IEEE P802.15
Wireless Personal Area Networks

Project	IEEE P802.15 Working Group for Wireless Personal Area Networks (WPANs)	
Title	Spectral mask for FSK	
Date Submitted	[June, 2010]	
Source	[James P. K. Gilb] [SiBEAM] [555 N. Mathilda, Suite 100, Sunnyvale, CA 94085]	Voice: [408-245-3120] Fax: [408-245-3120] E-mail: [last name at ieee dot org]
Re:	[d1P802-15-4g_Draft_Standard.pdf]	
Abstract	[This document describes changes to add an FSK mask to the draft.]	
Purpose	[To resolve comments in LB51.]	
Notice	This document has been prepared to assist the IEEE P802.15. It is offered as a basis for discussion and is not binding on the contributing individual(s) or organization(s). The material in this document is subject to change in form and content after further study. The contributor(s) reserve(s) the right to add, amend or withdraw material contained herein.	
Release	The contributor acknowledges and accepts that this contribution becomes the property of IEEE and may be made publicly available by P802.15.

2. Suggested text for 802.15.4g

2.1 Comment resolution items for FSK/GFSK

Figure 2—2-FSK modulation

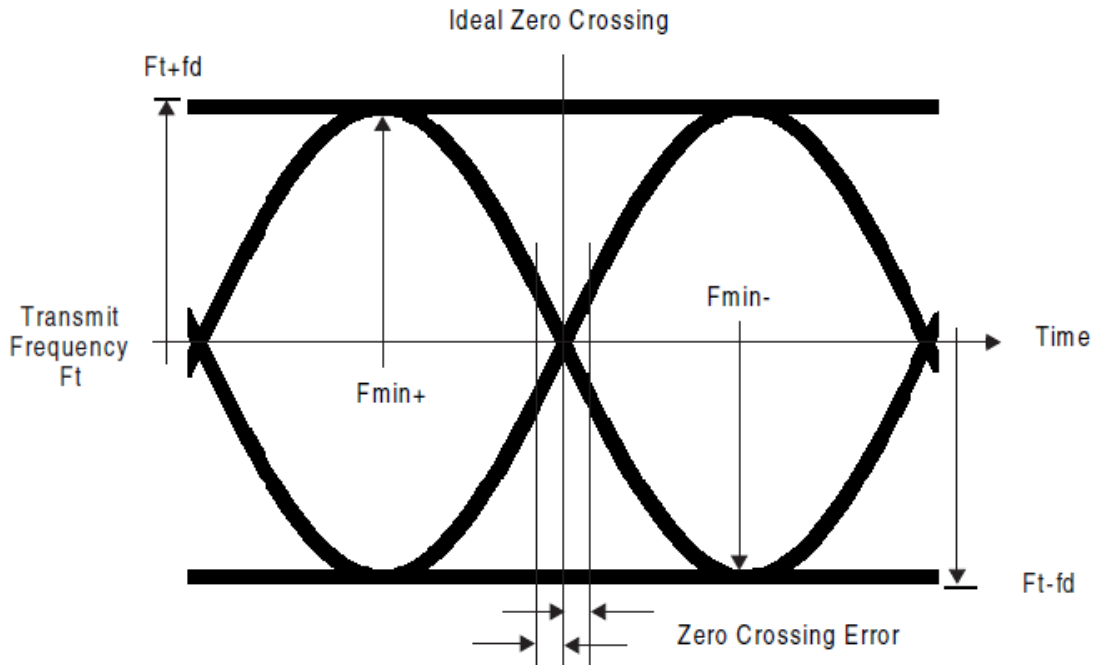
For comments: 332, 333, 334, 335, 336, 337, 360, 361, 362, 363, 364, 389, 390, 391, 392, 404, 405, 406, 1218, 1227, 1228, 1229, 1230, 1231, 1232, 1326, 1327, 1347, 1348, 1349, 1350, 1361, 1510, 1513, 1515, 1517, 1519.

The symbols and terms for 2-FSK signal is illustrated in Figure 2.

For 2-FSK, the error in the modulation, $\Delta f d$, at mid-symbol time shall be less than

- $\pm 0.2 * \Delta f$ for modulation indexes less than or equal to 0.5,
- $\pm 0.3 * \Delta f$ for modulation indexes greater than 0.5,

Resolution: Accept in principle, add the new subclauses defined in document 15-10-0331-01-004g, section 2.2, to the draft.

Figure 3—4-FSK modulation

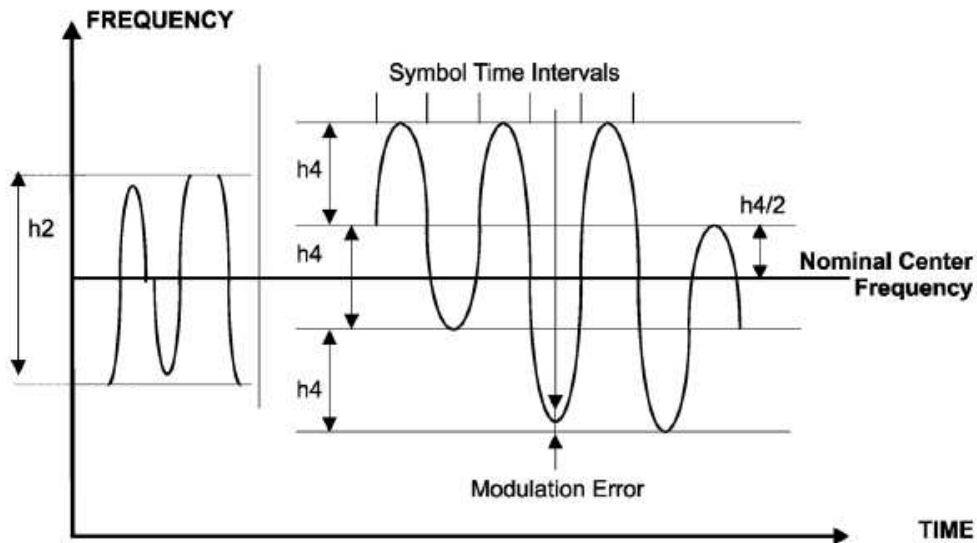
The symbols and terms for 4-FSK are illustrated in Figure 3.

For 4-FSK, the error in the modulation at mid-symbol time shall be less than $\pm 0.2 * \Delta f$, where Δf is defined in 6.12a.1.2.
